From: Timothy Ryan *TR*  
Rebecca Myrick *RLM*  
URS CorporationReference: Calvert Cliffs Nuclear Power Plant #3 TIS  
Response to Comments from SHA with respect to Intersection Improvements for  
the MD 2 / MD 4 Intersection

**RESPONSE TO MARCH 17, 2011 SHA COMMENTS ON  
TRAFFIC IMPACT STUDY DATED FEBRUARY 2, 2011**

*Based upon the SHA review comments provided on March 17, 2011 of the Traffic Study related to the proposed expansion at the Calvert Cliffs site in Lusby, MD prepared by KLD in cooperation with URS for UniStar, and follow up discussions with SHA, the comments are addressed below one by one, following each section of the review comments.*

**Figure MD231-01c**

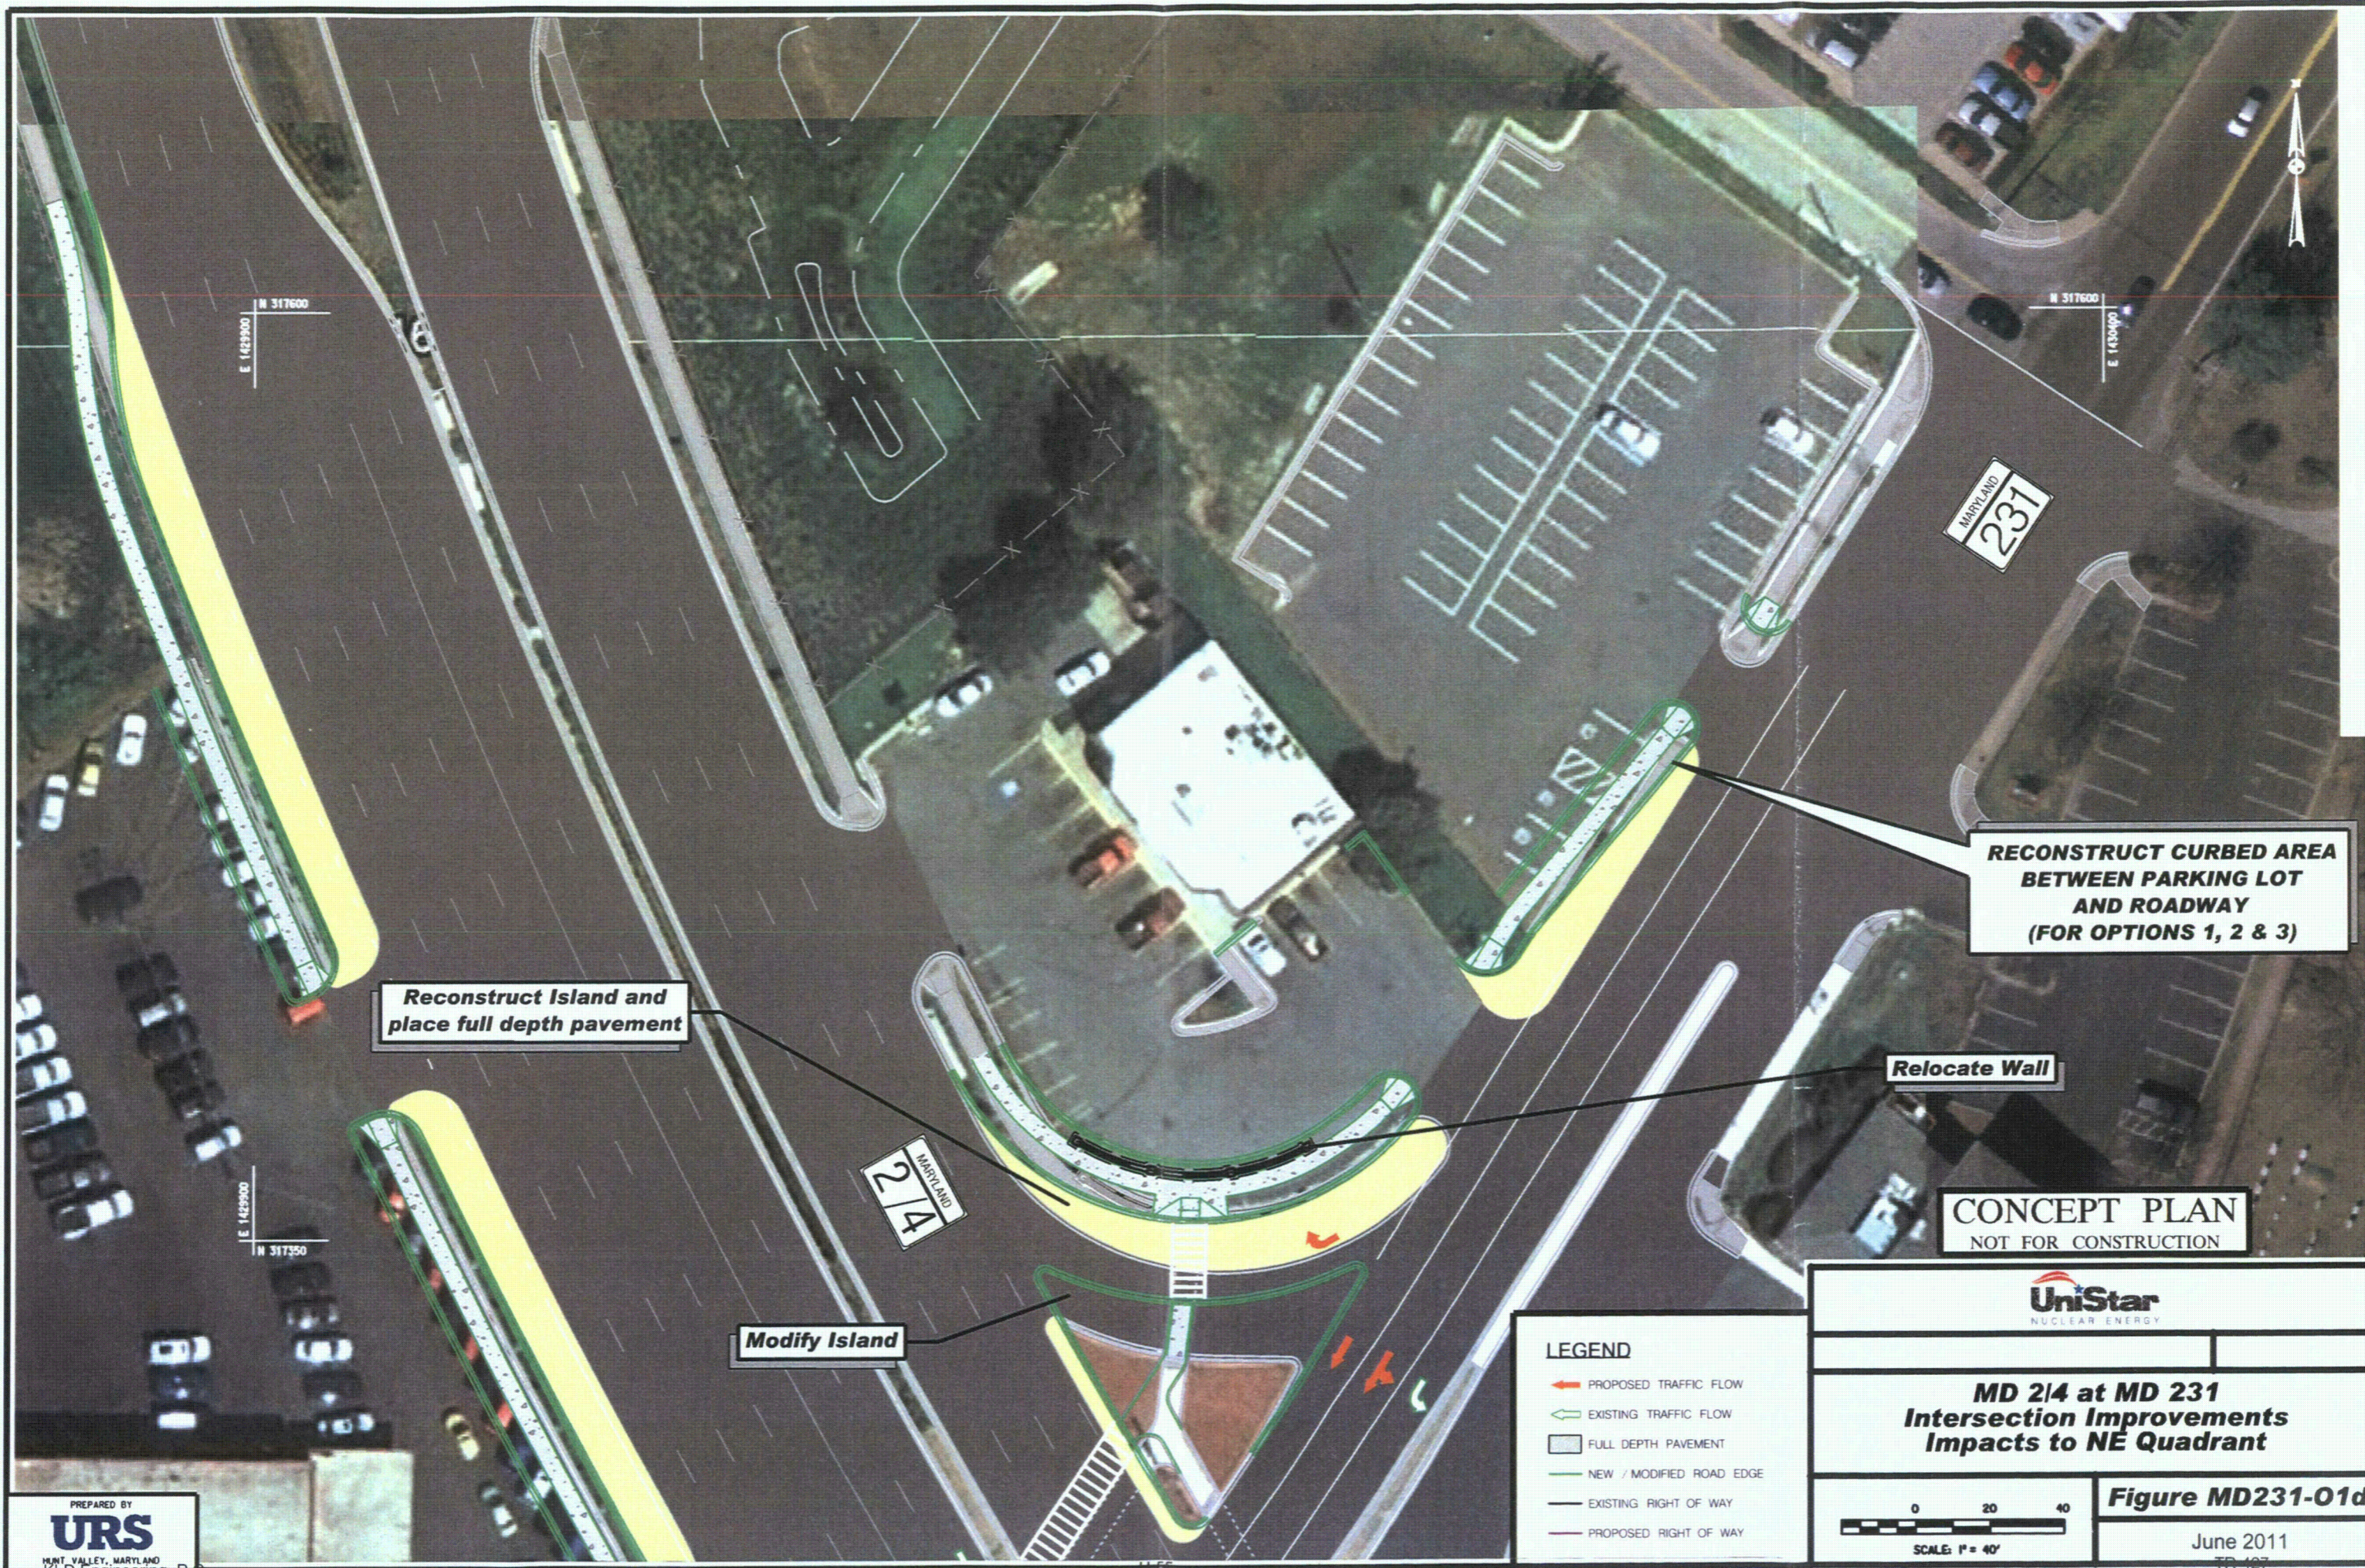
- 11) The existing third lane along southbound MD 2-4 at MD 231 becomes a lane drop at the next intersection 1500ft to the south (Old Field Lane/Sherry Lane). The concept plans must clearly indicate how two lanes would be dropped within 1500 ft., or if one of the lanes would be extended beyond the adjacent intersection.

Response: The proposed configuration extends the third lane beyond the adjacent intersection. The drawings related to the intersection of MD2-4 at MD 231 have been modified to include the adjacent intersection of MD 2-4/Old Field Lane/Sherry Lane and are included in the report.

**Turning Movement Summary  
and  
Level of Service**

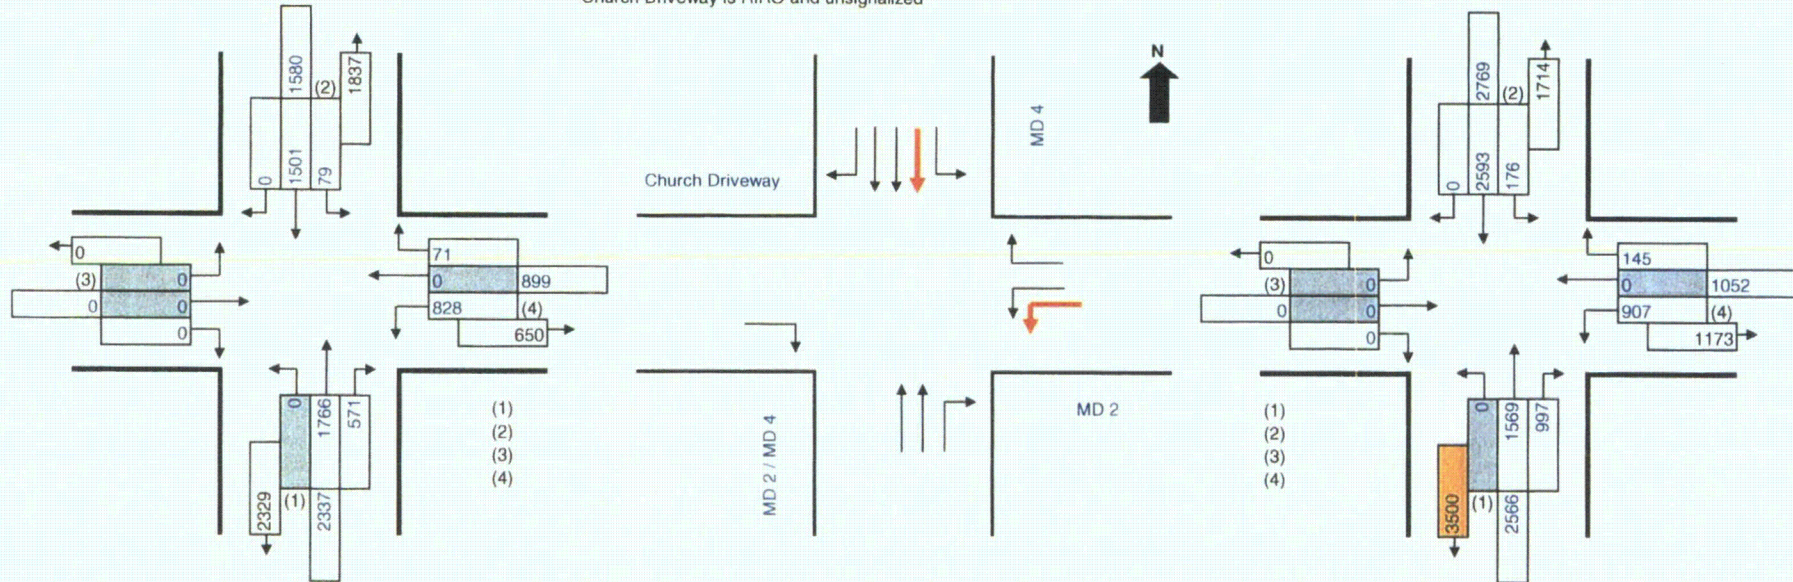
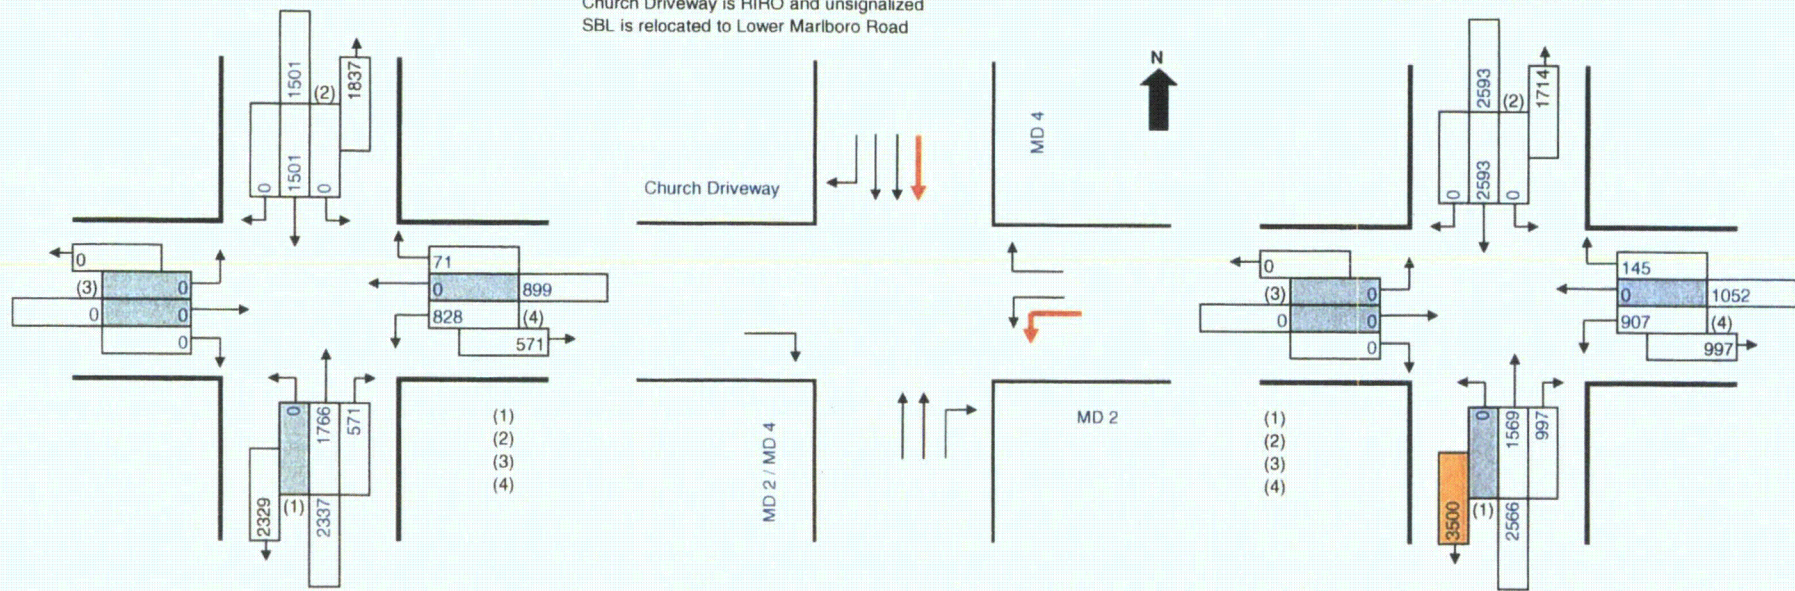
The first comment asked about the feasibility of relocating the left turn movement on southbound MD 4 to the intersection of MD 4 and MD 262/MD 262A (Lower Marlboro Road), just north of the MD 2 / MD 4 intersection. The relocation of this movement would allow the left turn movement from southbound MD 4 and the left turn movement from southbound MD 2 to operate concurrently, since the two movements would now be occurring at different intersections, which may improve the overall level of service (LOS) of the MD 2 / MD 4 intersection.

To answer this question, critical lane analyses were performed to determine if there is any benefit to the MD 2 / MD 4 intersection if the left turn movement from southbound MD 4 is relocated.

Using the 2016 peak construction traffic volumes, and Concept 1, which adds only a 3<sup>rd</sup> southbound through lane to MD 4 and a 2<sup>nd</sup> southbound left turn lane to MD 2, the intersection is expected to operate at LOS E in the AM peak hour with a volume to capacity (v/c) ratio of 0.97, and LOS E in the PM peak hour with a v/c ratio of 0.99 with the southbound MD 4 left turn lane still in place. With the removal of the southbound left turn volume from MD 4, the LOS is expected to remain at LOS E for both the AM and PM peak hours. The AM peak hour v/c ratio is expected to improve from 0.97 to 0.92, but the PM peak hour v/c ratio is expected to remain at 0.99. (The PM peak hour critical lane volume (CLV) is expected to improve by only two vehicles with the relocation of the southbound MD 4 left turn movement.)

These analyses, which are attached, show that relocating the southbound MD 4 left turn movement could improve operations in the AM peak hour, but that the relocation would be expected to have little to no effect on operations during the PM peak hour, which is the peak hour with the worst LOS for this intersection.
